Dawson Canyon Road Bridge over Temescal Wash

TECHNICAL MEMORANDUM

Subject: Bridge Inspection and Recommendations

Picture 1: Concrete Bridge Deck with Methacrylate Deck Treatment

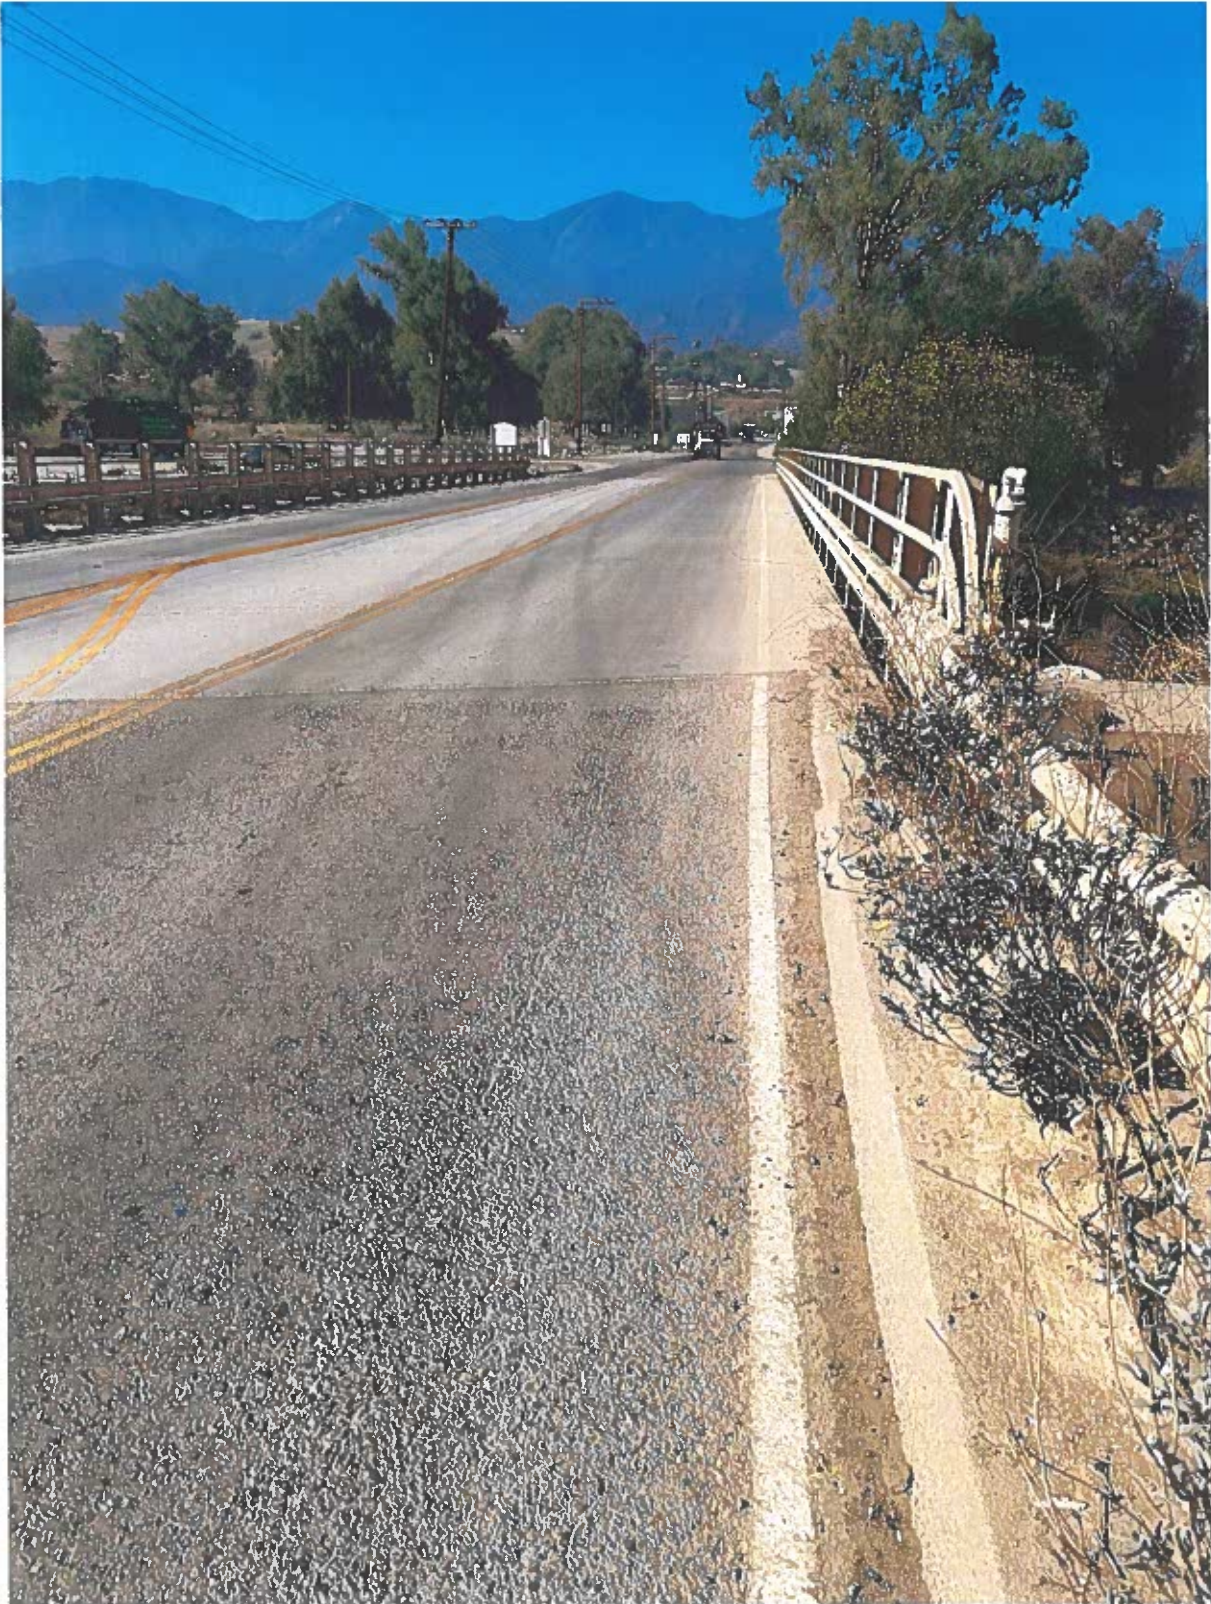
Condition: The existing methacrylate deck treatment that was completed in June 2020 is in fair condition (Picture 1). Some areas of the deck treatment are beginning to show signs of distress, most areas are sound and in good condition. The repairs completed in June 2020 at the areas of spalling are in good condition.

Recommended Work: Deck shall be reinspected annually. It is anticipated that in 2 years, near the end of the expected life of the methacrylate deck treatment, that additional deck treatment or deck overlay may be recommended at that time.
